## Regional Development Assessment Panel Agenda

**Meeting Date and Time:** Tuesday, 14 April 2026; 9:30am  
**Meeting Number:** RDAP/69  
**Meeting Venue:** 140 William Street, Perth

- 3.1 Lot 13 & 14 (Street No. 74 & 76) Blackwood Avenue, Augusta –  
Proposed Multiple Dwellings and Mixed Use (Office, Consulting Rooms,  
Restaurant, Shop) – DAP/25/03030

**PART B – Item 3.1 – LOT NO. 13 & 14 (STREET NO. 74 & 76) BLACKWOOD AVENUE, AUGUSTA – PROPOSED MULTIPLE DWELLINGS AND MIXED USE (OFFICE, CONSULTING ROOMS, RESTAURANT, SHOP)**

Image 1: height of proposed Multiple Dwellings in relation to the height of the existing units at the rear of the site.

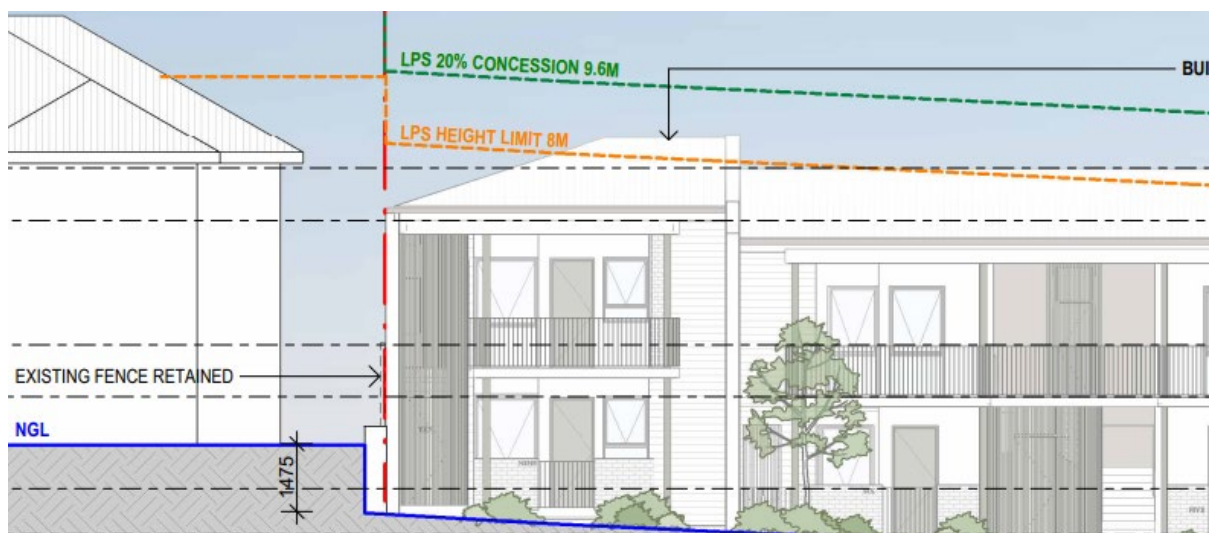
In regard to the minor height variation proposed for the multiple dwellings the applicant has amended the design in response to submissions received by changing the roof to a hipped design which reduces the height of the rear boundary wall, and reduced the FFL by 100mm. The overall building height has reduced from the originally proposed 8.9m to 8.34m.

All setbacks to the Multiple Dwellings are compliant. As outlined in Image 1 below, the roof of the Multiple Dwellings would sit almost 2m lower than the roof of the adjoining rear units such that they would not appear out of scale with the surrounding development. They would sit well back from the street boundary and are not expected to cause adverse impacts on the surrounding area or streetscape as a result of the variation.

The applicant has agreed to provide additional screening to the Unit 10 upper floor balcony, which would prevent any overlooking from the Multiple Dwellings onto neighbouring sites. This is reflected as a recommended condition of approval.
